WATRY ENGINEERING INCORPORATED
Our review of these shop drawings is only for general compliance with the structural drawings and specifications. Our review does not guarantee in any way that the shop drawings are correct, nor does it infer that they supercede the structural drawings.
☒ No Exceptions Taken
☐ Make Corrections Noted
☐ Revise and Resubmit
By: [illegible] Date: 6/7/82

GENERAL NOTES & DETAILS
THE WATERFRONT OFFICE TOWERS
STOCKTON CALIFORNIA

BLDG. 2 - 1ST FLOOR PLAN
STRAND LAYOUT
PROJECT: THE WATERFRONT OFFICE TOWERS
STOCKTON CALIFORNIA

WATERFRONT TOWERS STOCKTON, CA	82-12
SCALE	REVISIONS / BY / DATE
DATE 3-10-82	
DR'N CSD CKD	
APVD	
TITLE BUILDING 1 SHEAR WALL DOWELS	NO Dwg E

BLDG. 2 - 5TH FLOOR PLAN
P.T. STRAND LAYOUT

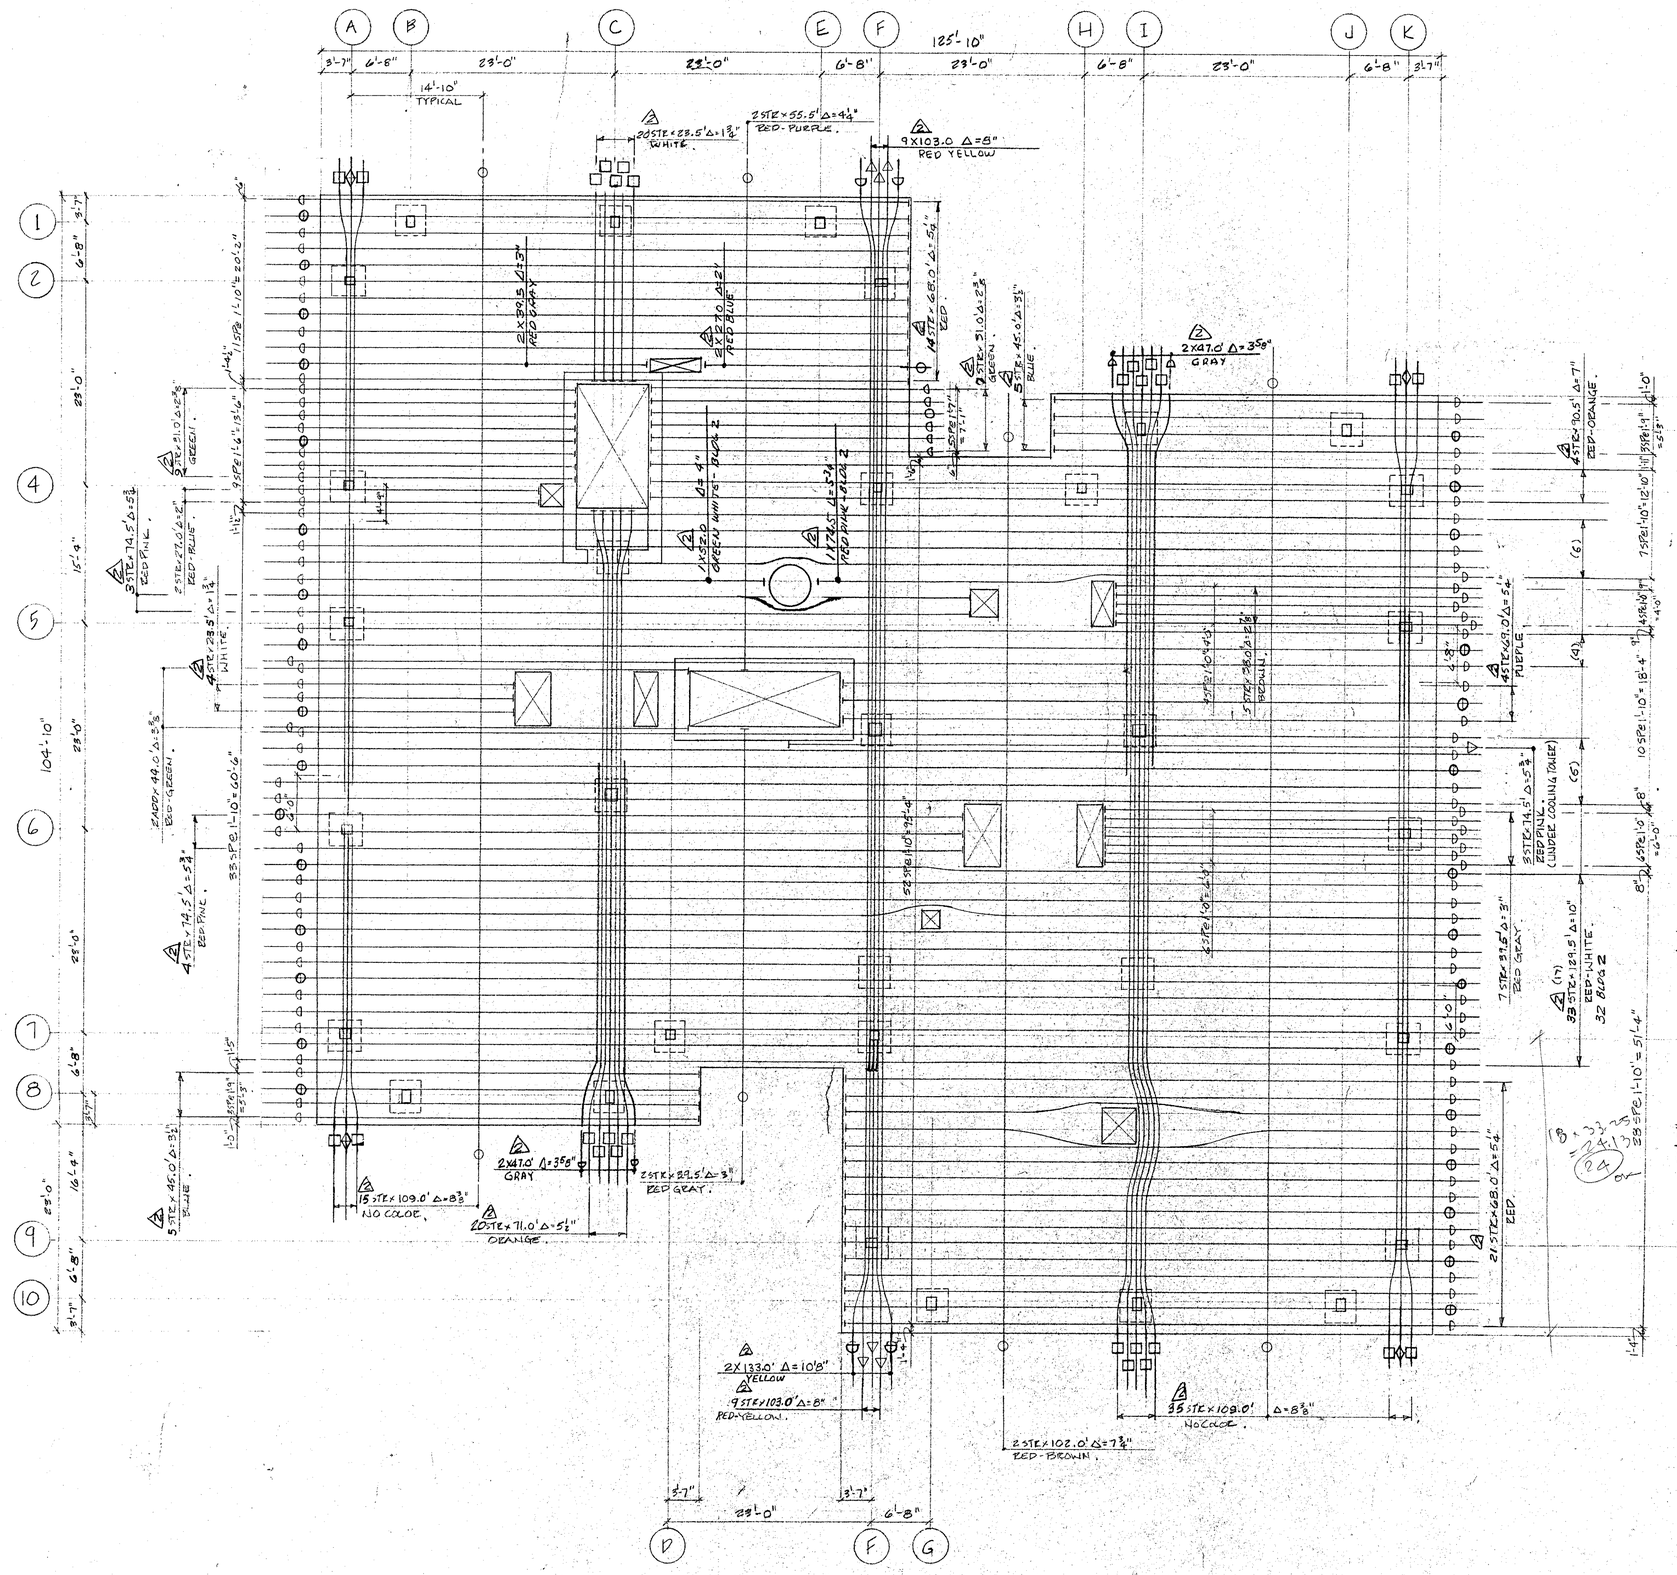
add (18-13.5) 17.67
17.72 tendons
13

JOB NAME WATERFRONT TOWERS CONT. NO. 82-12 DRWG. NO. 8A

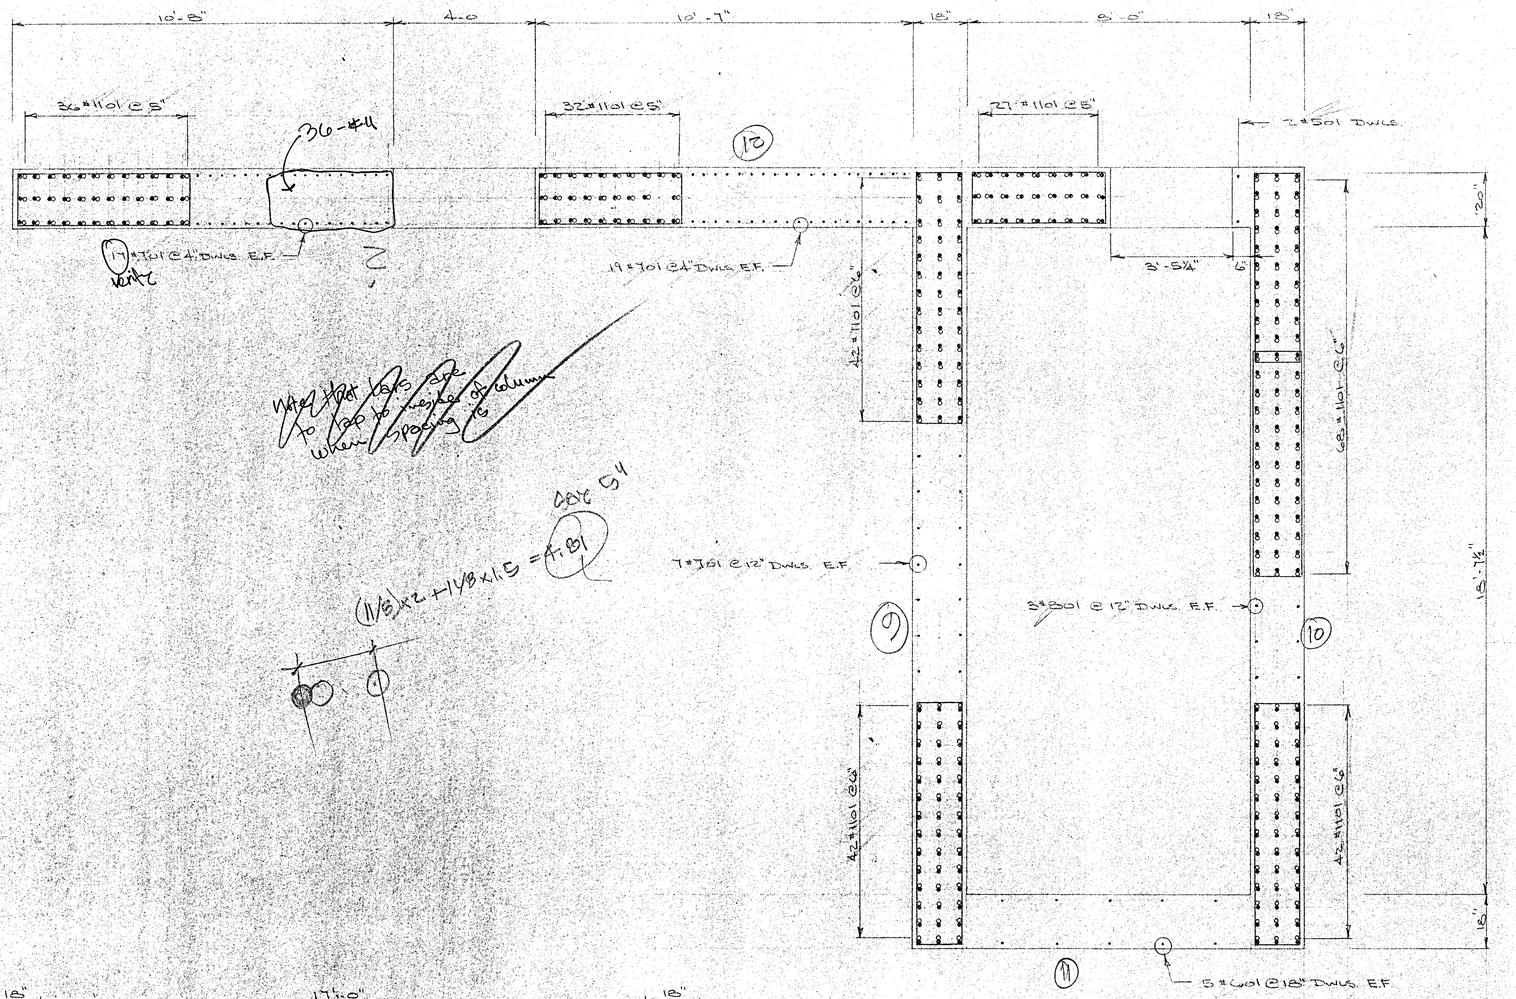
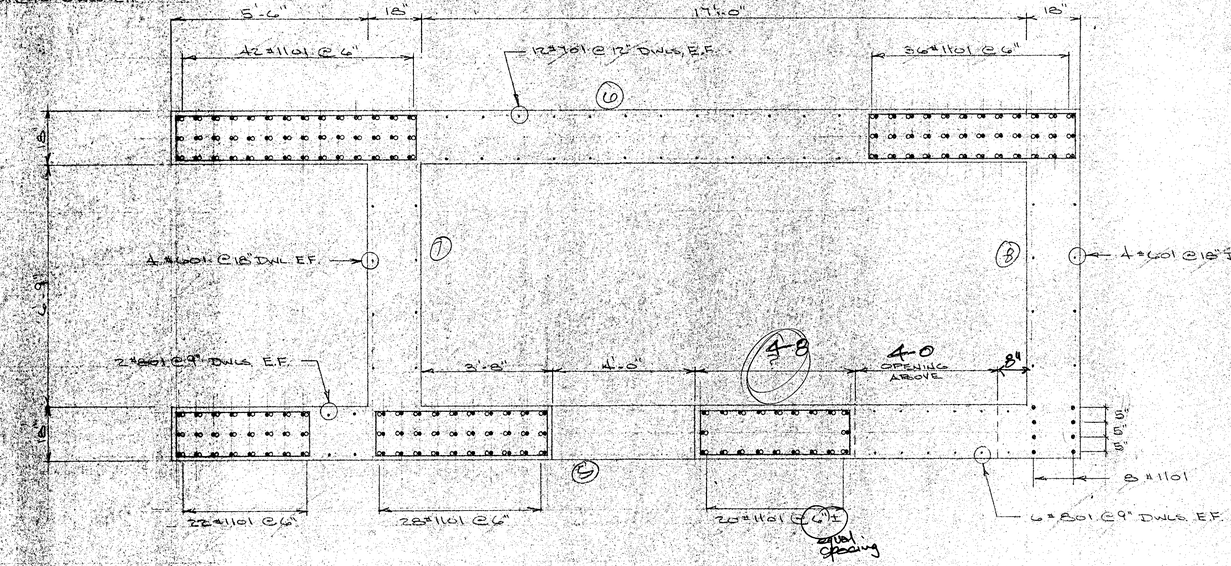
Space bars such that 28 bars go past door opening above

TITLE BLDG 2 - COLUMNS NO. DWG 9

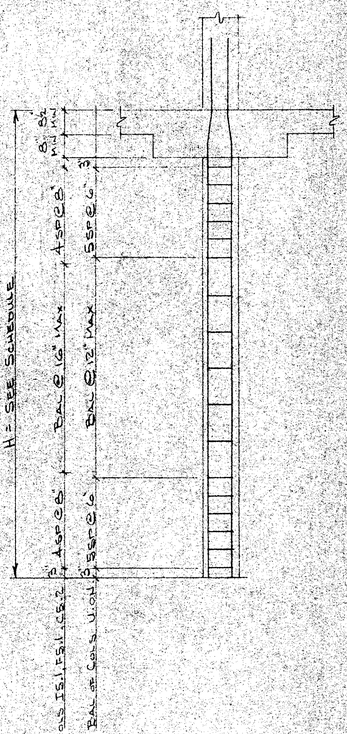
draw detail for transition from 12x12 to 14x14 for C4

2ND FLR.
16" WALLS

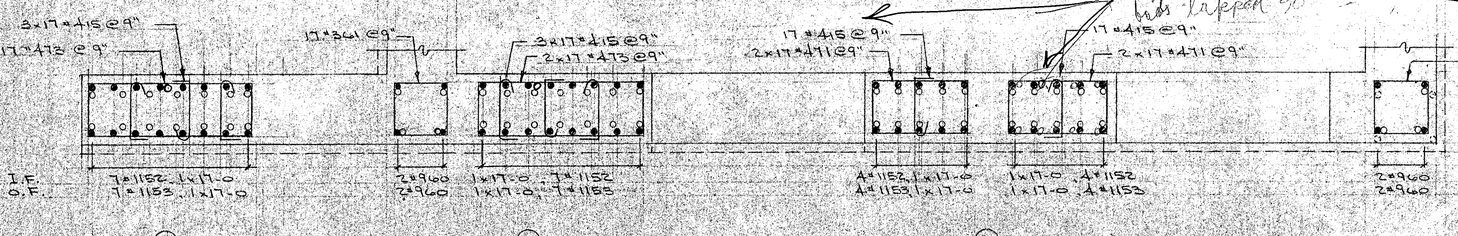
supported trimed
has lapped 90°
